**ZONING AMENDMENT,
& SUBDIVISION STAFF REPORT**

Date: April 19, 2007

University Oaks Office Park Subdivision

SITE PLAN

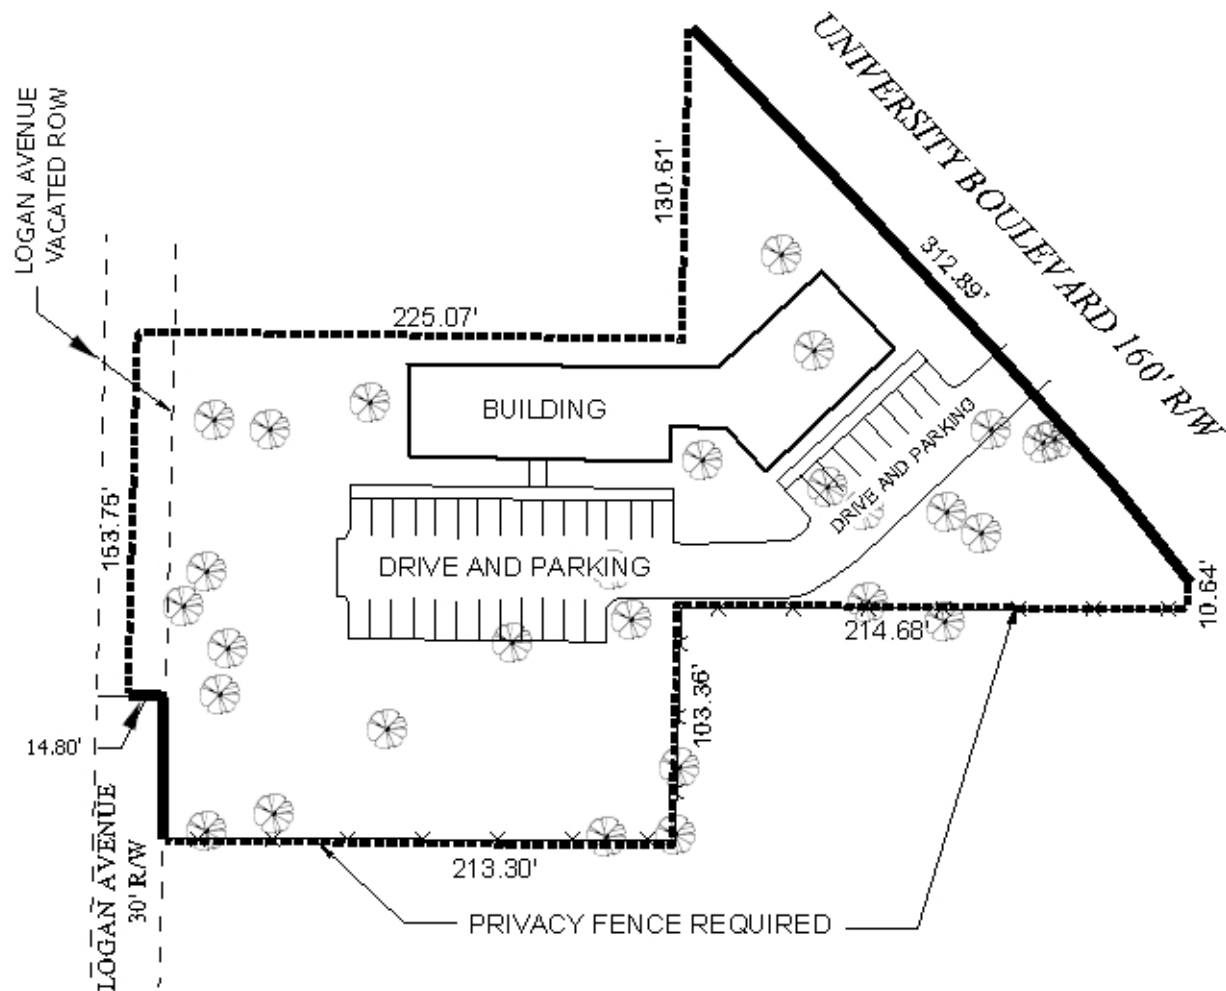
A 10-foot buffer strip and privacy fence along the South property line of the site is required by the Zoning Ordinance; however, to further protect the separation of commercial and residential use the proposed parking should also be shifted to provide a 10-foot buffer from the residential property.

The proposed Subdivision will create one lot with approximately 312-feet of frontage onto University Boulevard and approximately 74-feet along Logan Avenue. Due to the frontage and location of the development, it is recommended that the development be limited to one curb-cut onto University Boulevard, with the size, design and location to be approved by Traffic Engineering and conform to AASHTO standards and that access to Logan Avenue be should be denied..

As illustrated on proposed site plan submitted with the application, use of the site, including the demolition of the existing structure, dumpster screening, buffer requirements, landscaping and tree planting requirements must comply with all applicable municipal codes and ordinances.

Rezoning: Based upon the preceding, the Rezoning request is recommended for Approval, subject to the following conditions: 1) completion of the Subdivision process; 2) denial of access to Logan Avenue; 3) provision of a 10-foot wide buffer (to include parking) and 6-foot high wooden privacy fence along the South property line; 4) the provision of screening the dumpster with a minimum 6-feet high solid wooden fence; 5) full compliance with the tree and landscaping requirements of Section 64-4.E. of the Zoning Ordinance; and 6) full compliance with all other municipal codes and ordinances.

Subdivision: Based upon the preceding, the Subdivision request is recommended for Tentative Approval, subject to the following conditions: 1) placement of a note on the Final Plat stating that the development is limited to one curb-cut onto University Boulevard, with the size, design and location to be approved by Traffic Engineering, and conform to AASHTO standards; 2) the placement of a note on the Final Plat denying access to Logan Avenue; 3) depiction and labeling of a 10-foot wide buffer (to include parking) and 6-foot high wooden privacy fence along the South property line; and 4) labeling of the lot with its size in square feet; and 8) full compliance with all other municipal codes and ordinances.
